Crookwell 2 Wind Farm – Modification 2

Response to Submissions and further information subsequent to a site inspection with the NSW Department of Planning and Environment and the Departments Independent Expert Mr Terry O’Hanlon.

Plate 1 – Google Earth extract, R60 Pejar Park illustrating approved C2WF Mod 1 wind turbines F48 and F50 with partial blade visible above ridgeline

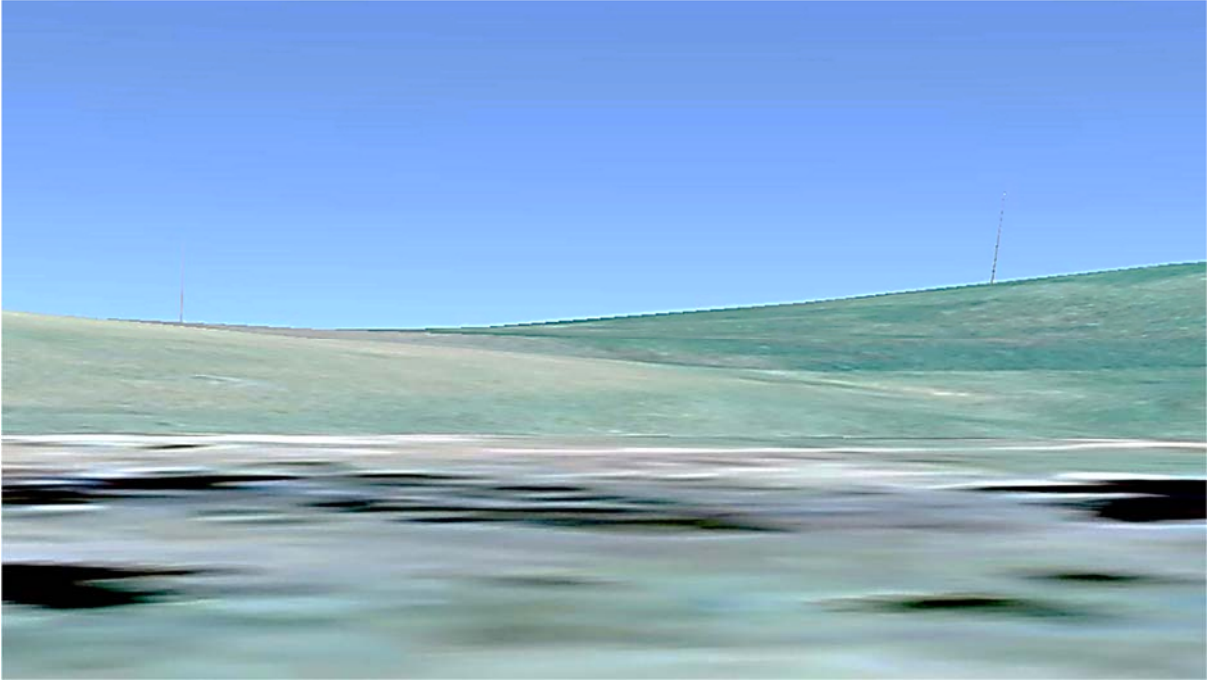
Review of dwelling R60 (Pejar Park) C2WF Mod 2 VIA

The C2WF Mod 2 VIA noted that there would be a minor change in the composition or contrast between the approved Mod-1 and proposed Mod-2 development and the surrounding landscape. This occurs where the approved Mod-1 visible wind turbines F48 and F50 would extend above the hill with turbine hubs partially visible. Landform rising to the west, and tree planting surrounding the main dwelling would also screen views toward the majority of approved Mod-1 and proposed Mod-2 wind turbines.

Our review confirms that the overall visibility of the C2WF Mod 2 wind turbines F48 and F50 would be restricted to a partial view of each wind turbine nacelle and blades as they extend horizontal to and above the nacelle.

Plates 1 and 2 illustrate indicative views toward the C2WF Mod 1 and Mod 2 wind turbines F48 and F50 to the west of Pejar Park. The Plates illustrate the general extent of wind turbine visible between each Mod, but do not illustrate the view from the west of the Pejar Park residential dwelling.

Plate 3 – Google Earth extract, R120 Elmgrove illustrating approved C2WF Mod 1 wind turbines

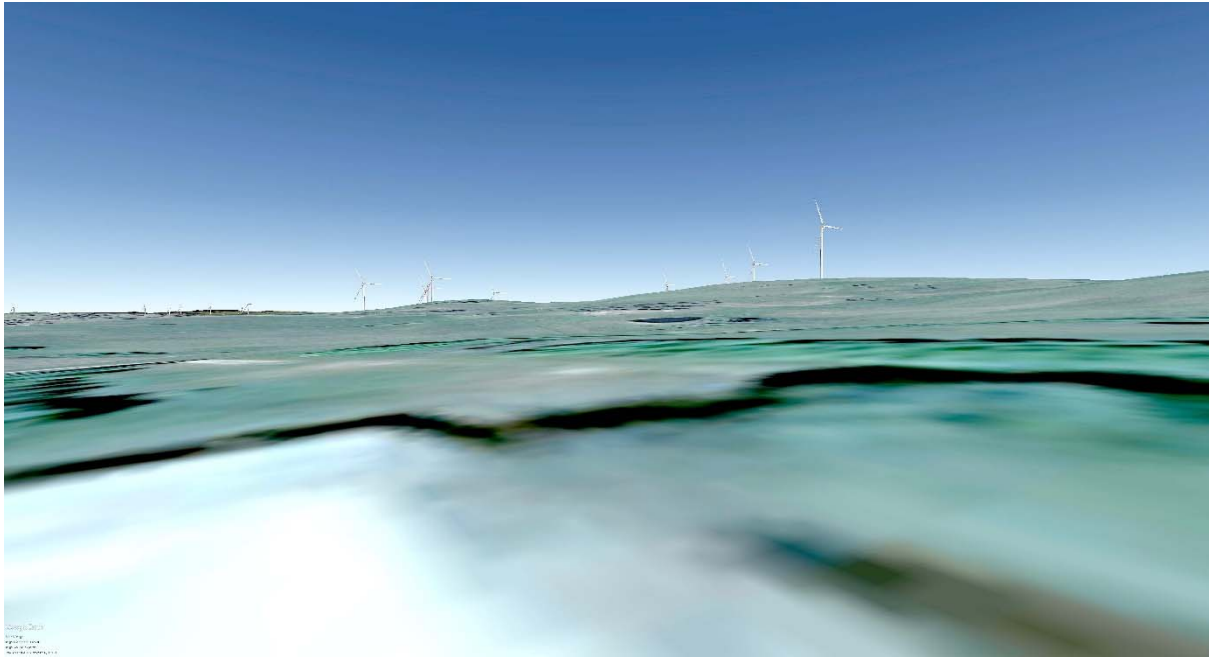
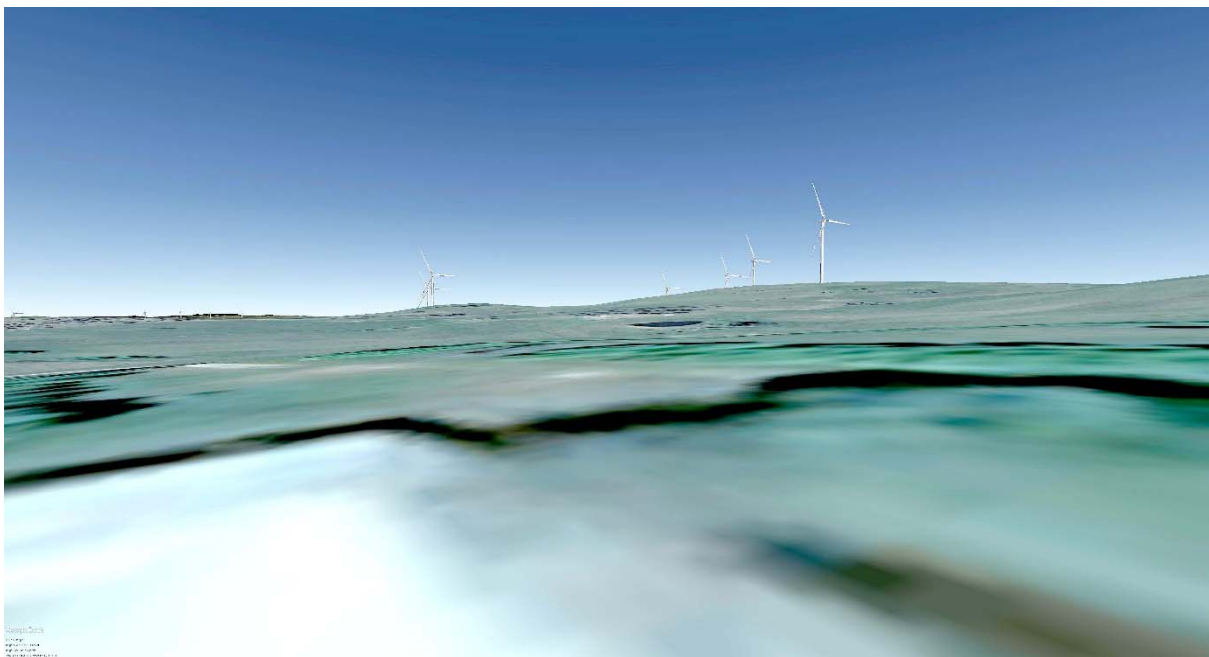
Review of dwelling R120 (Elmgrove) C2WF Mod 2 VIA

The C2WF Mod 2 VIA noted that observable scale of change would be noticeable between the Elmgrove dwelling and closest approved C2WF Mod-1 wind turbine. Views toward the approved C2WF Mod-1 would be altered by the removal of three approved Mod-1 wind turbines F6, F8 and F9 within the cluster south west of the dwelling. There would be limited change in the composition or contrast between the approved Mod-1 and proposed Mod-2 development and the surrounding landscape. Planting surrounding the dwelling would also screen and filter views toward both approved Mod-1 and proposed Mod-2 wind turbines.

Plates 3 and 4 illustrate indicative views toward the C2WF Mod 1 and Mod 2 wind turbines to the south west of Elmgrove.

Table 01 - Change in approved and modified view angles at varying distances

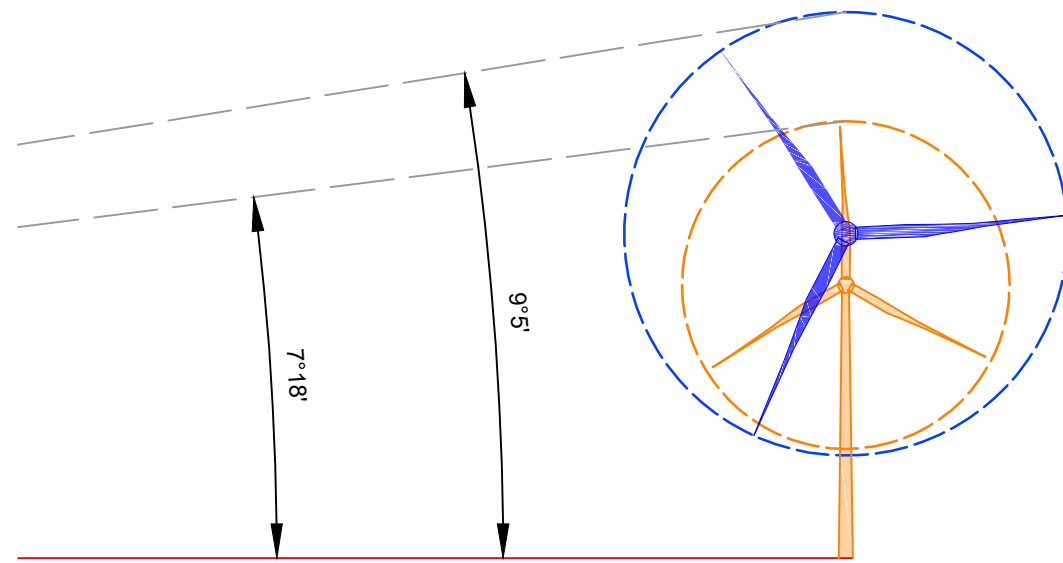
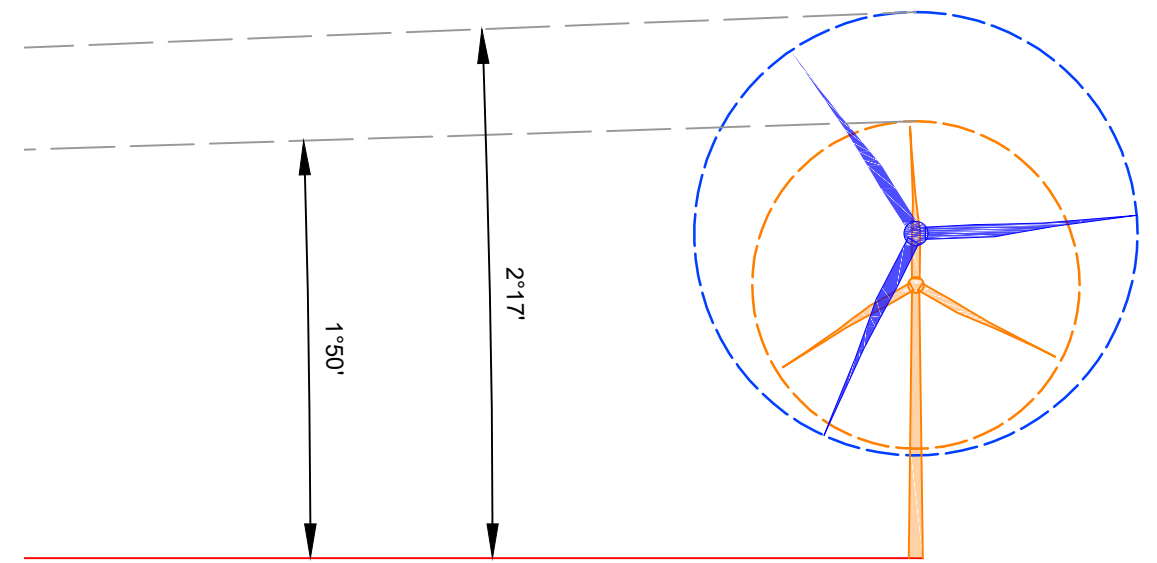
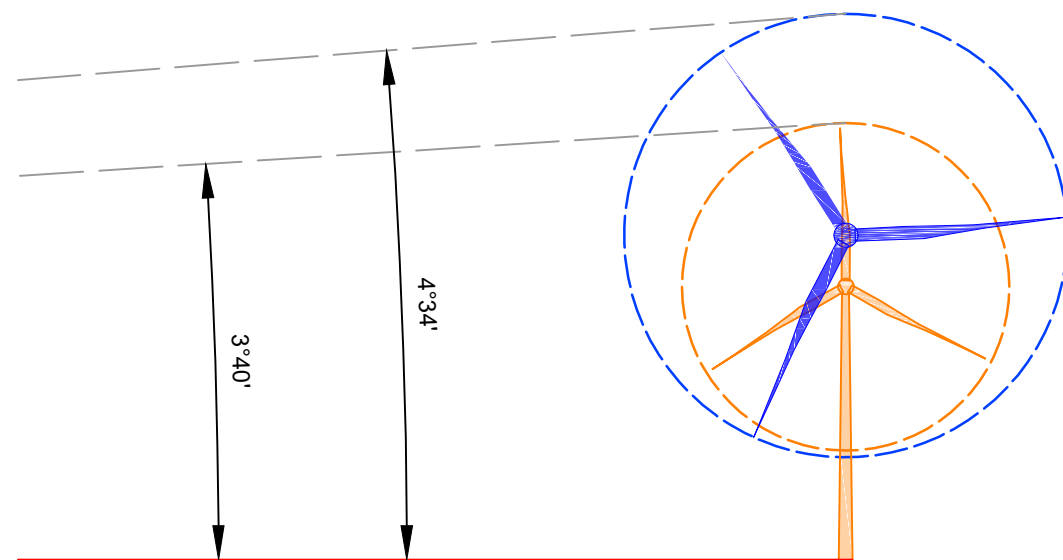
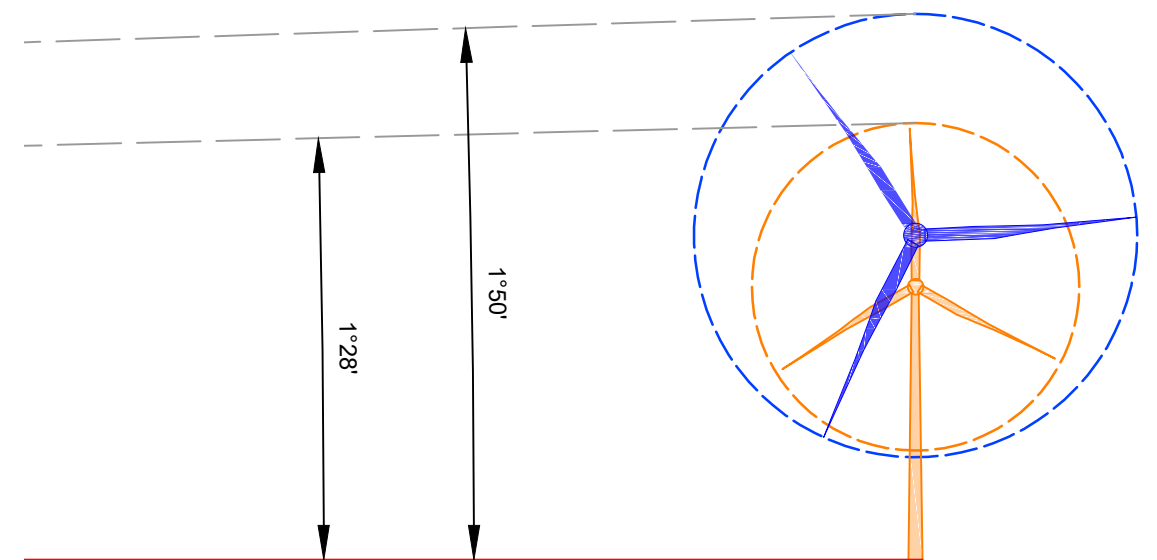
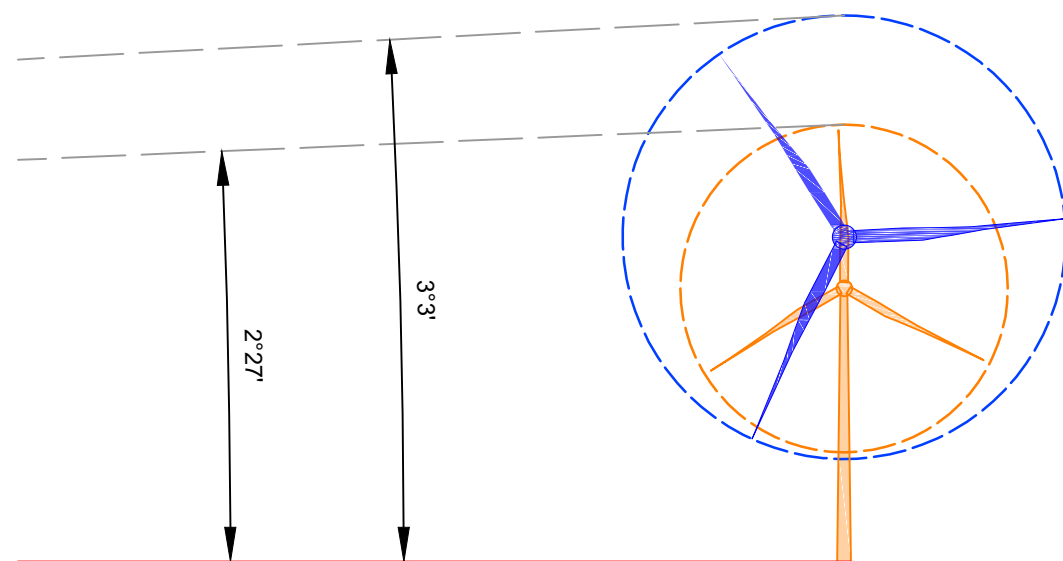
Mr Homewood tries to minimise the modification with diagrams showing how negligible the additional angle and height is at 2km.

The diagrams (C2WF Mod 2 VIA Figures 5 and 6) do not attempt to minimise the modification. The diagrams simply illustrate differences in the C2WF Mod 2 and approved C2WF Mod 1 wind turbine dimensions and view angle at distances of 2km and 5km.

The C2WF Mod 2 VIA notes that 'within the parameters of human vision, the proposed Mod 2 wind turbines are not considered to give rise to an increased level of visual magnitude over and above that determined for the approved C2WF Mod 1 development'.

Appendix A - Figures includes additional Figures PS01 and PS02 which illustrate the additional view angle above the approved C2WF wind turbine at distances of 1km, 2km, 3km; 4km and 5km.

Figure POS 3 C2WF Approved Mod-1 and proposed Mod-2 layout

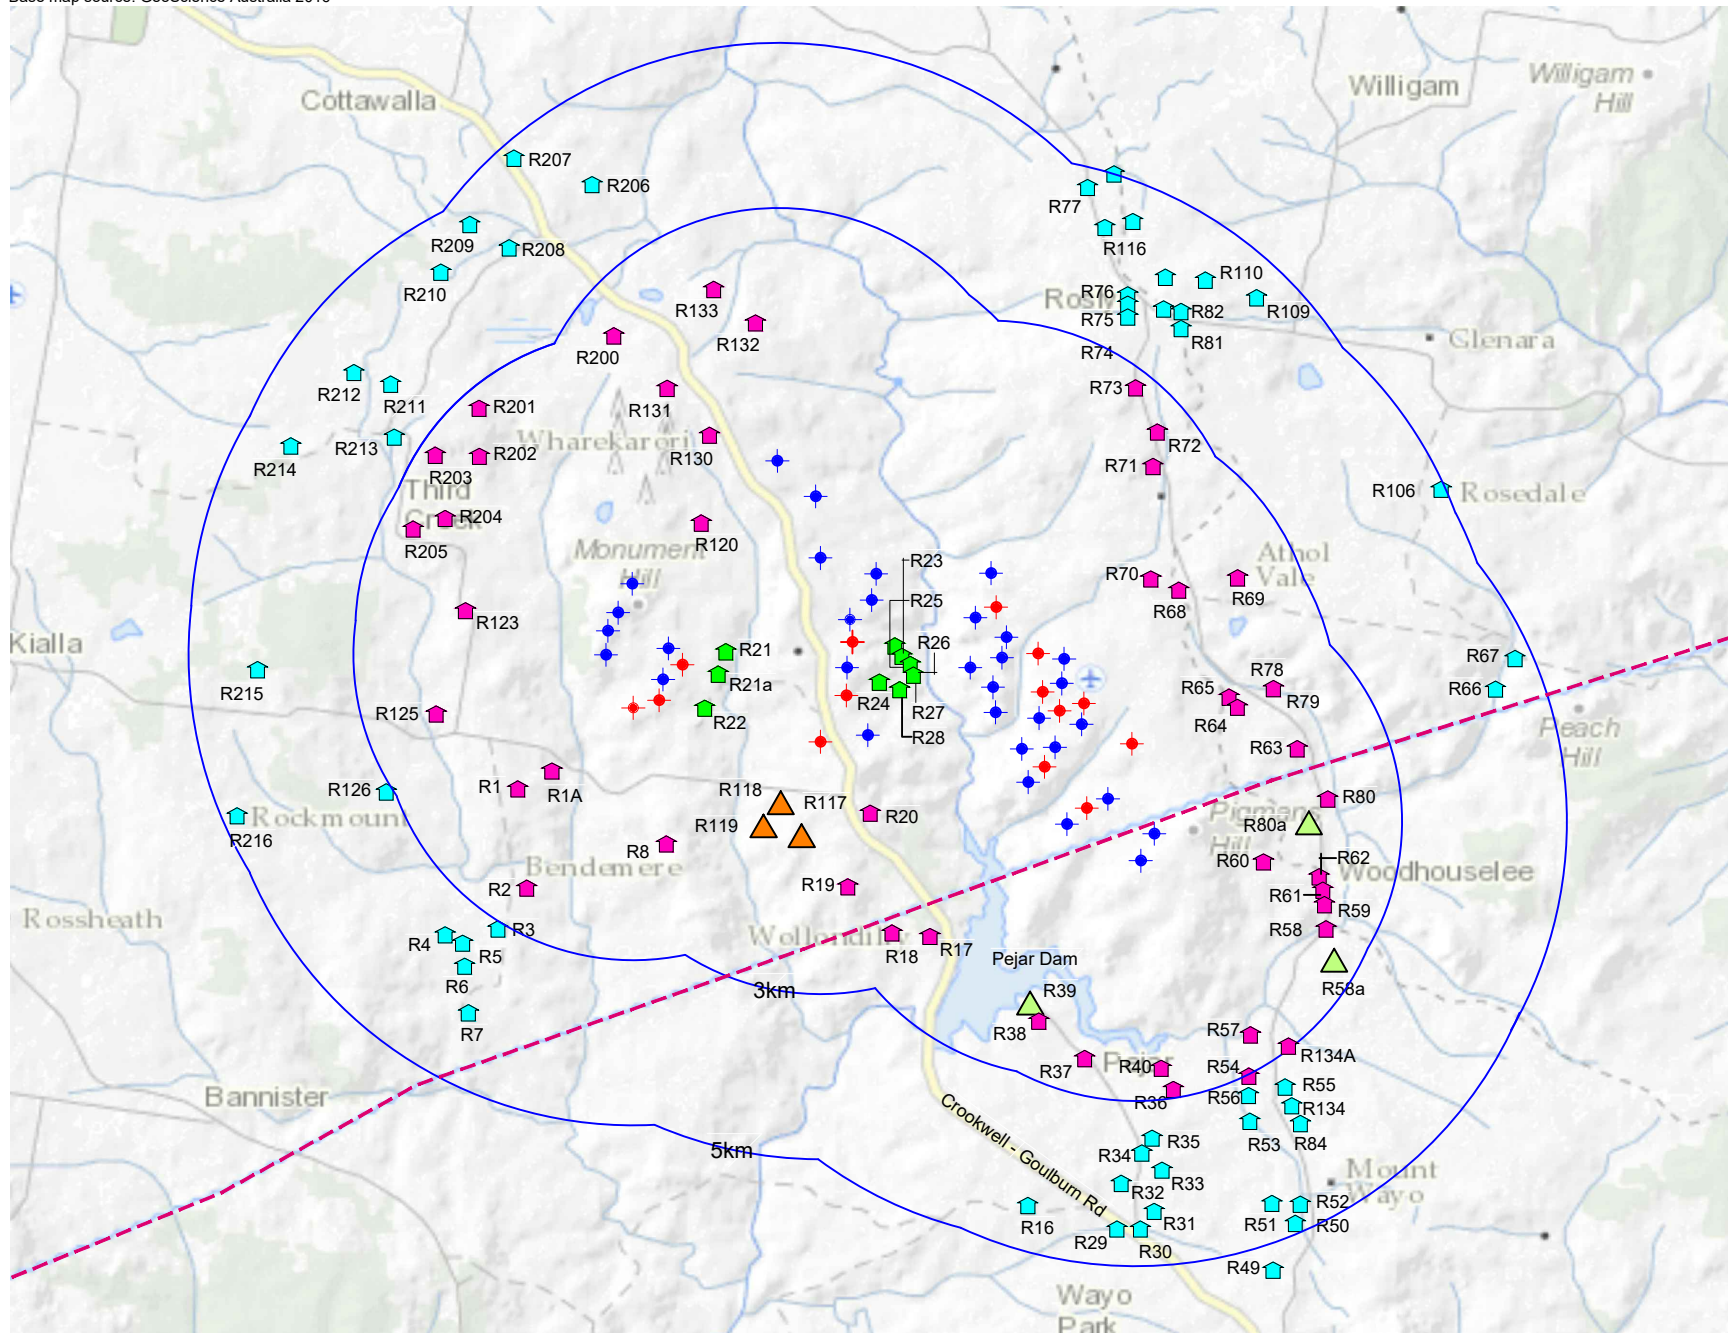
Update to C2WF Mod 2 Figure 1 Approved Mod-1 and proposed Mod-2 layout

The C2WF Mod 2 Figure 1 has been updated and amended to:

- Remove wind turbine F9. The approved C2WF Mod 1 F9 wind turbine has been removed by the Proponent
- Remove dwelling R124. Dwelling R124 has been verified by GBD and the NSW Department of Planning and Environment as an agricultural shed
- Add dwelling R1a which has been confirmed as a DA approved shed conversion and residential dwelling
- Add dwelling R134 recent construction
- Add dwelling R134A recent Development Approval (not constructed)

The amended Figure 1 is included in Appendix A – Figures as PS03.
